MARK III CONTAINMENT HYDROGEN CONTROL OWNERS GROUP

November 14, 1985
HGN-066

SUBJECT: Response to Questions from
Staff in September 9 Telecon

SPRAY FLOW (S.11)

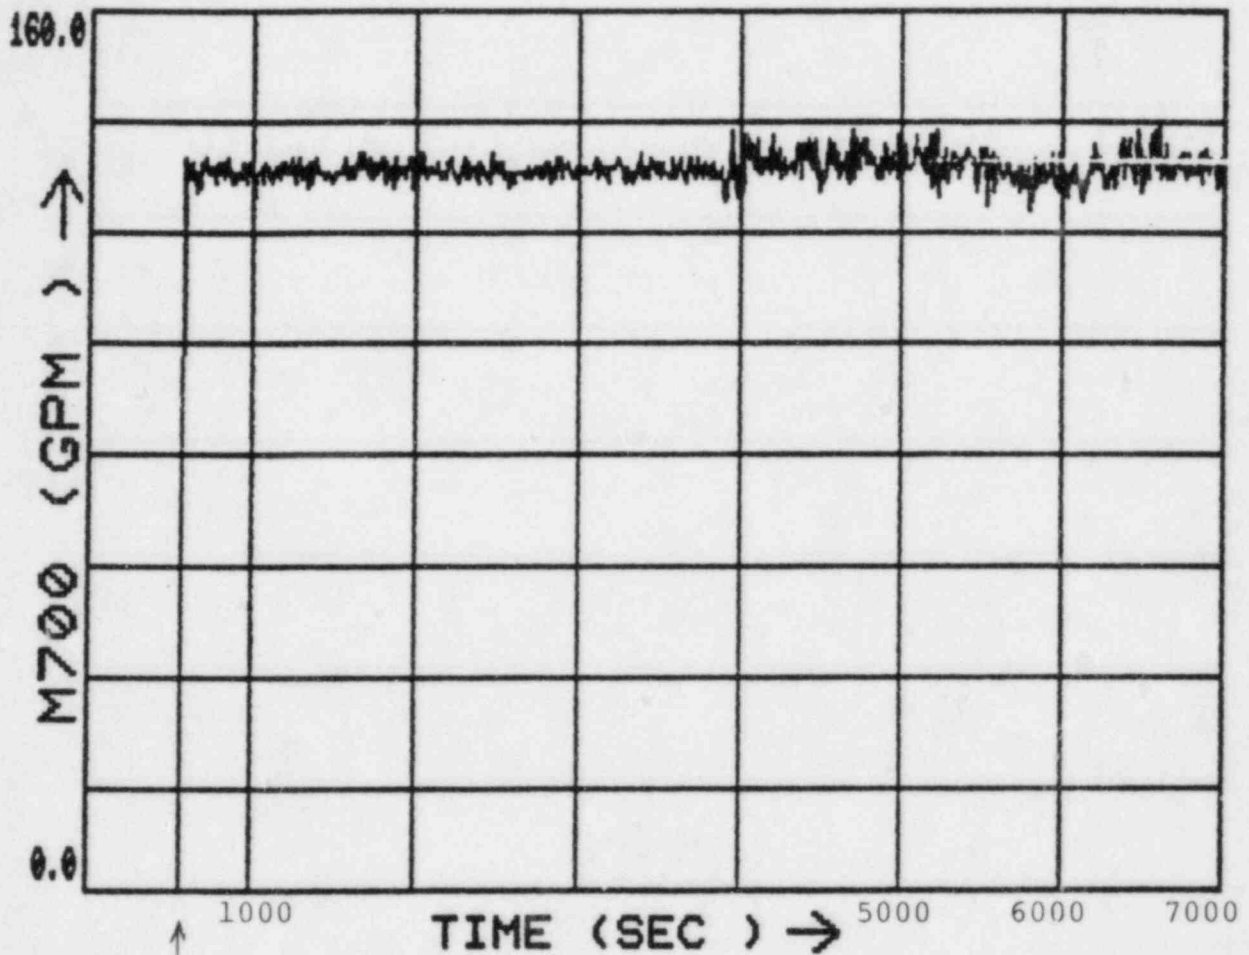
- 1) information identifying the point at which sprays were initiated in the 1/4 scale test facility for scoping tests S.11 and S.12.2;
- 2) thermocouple data for instruments T-200, T205 and T208 for tests S.09 and S.11; and
- 3) a discussion of the variation in test results between scoping tests S.01, S.02, S.03 and S.05.

In response to Item 1, plots of spray flow data and the associated hydrogen injection profiles for tests S.11 and S.12.2 are provided in Attachment 1. The spray flow plots indicate both the time at which the simulated containment spray system was actuated and the corresponding system flowrate. The hydrogen injection profiles reflect the case B hydrogen release histories which were used in both scoping tests. As indicated by these plots, the containment sprays were actuated after the peak hydrogen injection rate had occurred.

SPRAYS ACTUATED @ ~650 SECONDS (15:57:45)
